# **Building Code of Australia**

## **Assessment Report**

**Project Address: 263 – 275 High Street, Maitland  
New Administration Building**

Report Number: 183885

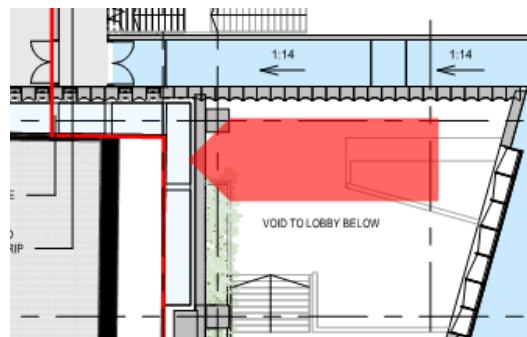
Openings in the southern elevation of the new building are within 6m of the existing building on Basement Level, Ground Floor and Level 1. These openings are to be protected.

Openings in the western elevation of the building exposed to the Town Hall Building will require protection.

A fire engineered solution may negate the need for these openings to be protected.

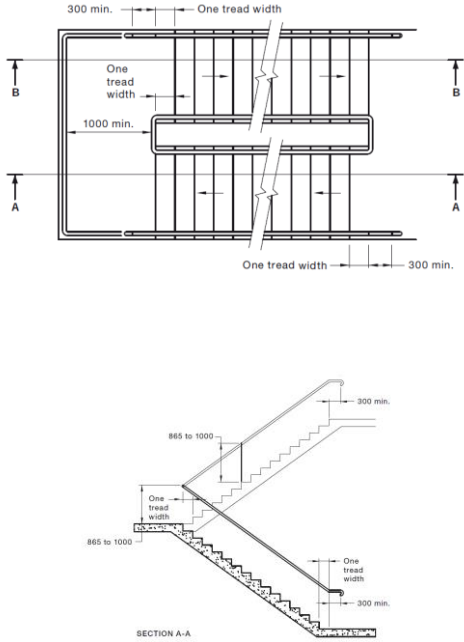
BCA Clause	Title	Assessment and Comment	Status
D1.2	Number of exits required	Ground Level to Level 2 are required to be provided with a minimum of one exit.  The basement is required to have access to at least two exits	Capable of complying
D1.3	When fire isolated exits are required	The two fire stairs located on the southern side of the building connect 4 storeys and are required to be fire isolated.	Capable of complying
D1.4	Exit travel distances	<b>Class 5 and 7a parts</b> - No point on a floor must be more than 20 m from an exit, or a point from which travel in different directions to 2 exits is available, in which case the maximum distance to one of those exits must not exceed 40m.  The distance to a point of choice may exceed 20m on office levels once fitout is taken into consideration. Extended distance to a point of choice of up to 30m may be performance justified.	Performance solution
